IEEE P802.11
Wireless Access Method and Physical Layer Specifications

Title: Proposal to correct the DTIM and TIM elements defined in section 4.

This document proposes a change of the currently specified DTIM and TIM fields used in Beacon frames. The intend is to improve consistency, remove current limitations, and correct errors.

4.4.2.2 Traffic Indication Map (TIM)

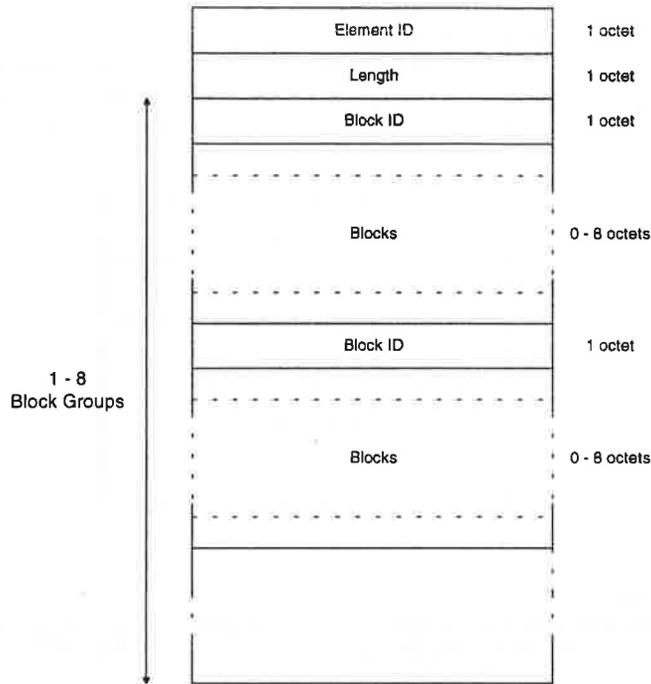
- 1- The suggested encoding scheme allows only 512 stations, and is not extendable, as currently described.
- 2- An SID of zero encoding should be possible to indicate BC/MC traffic. The definitions are currently not sufficient clear.
- 3- The Block description is ambiguous, and the formula used is not correct.
- 4- It is unclear when Block ID's need to be specified, if there is for instance no traffic buffered.
- 5- The Block Identifier figure does not follow the octet representation conventions as specified in section 1.5.

UPDATE FIGURE to add DTIM period and DTIM count (Can't update the Visio drawing).

UPDATE FIGURE to show that one TIM can contain as many as 28 Block Groups.

The TIM Element information field shall contain between one and a maximum of twenty eight block groups, with each block group consisting of a block identifier followed by 0 to 8 one-octet blocks. Each bit within a block shall indicate whether a frame is currently buffered for a station with a particular Station ID. There is a one-to-one mapping between the bits in a virtual bit map and the station IDs. The virtual bit map is maintained within the access point; the actual transmitted TIMs are a compressed representation of the virtual bit map. If multiple TIMs are in one Beacon, then the concatenated Block group information of all TIMs within the same Beacon frame will represent the virtual bit map.

Block (8 bits) Each bit corresponds to a specific station within the block. If this block represents the Nth block within the virtual bit map, of Block Group G, then Bit M within the block shall correspond to the station with Station ID equal to $(G-1) * 64 + 8 * (N-1) + M$.
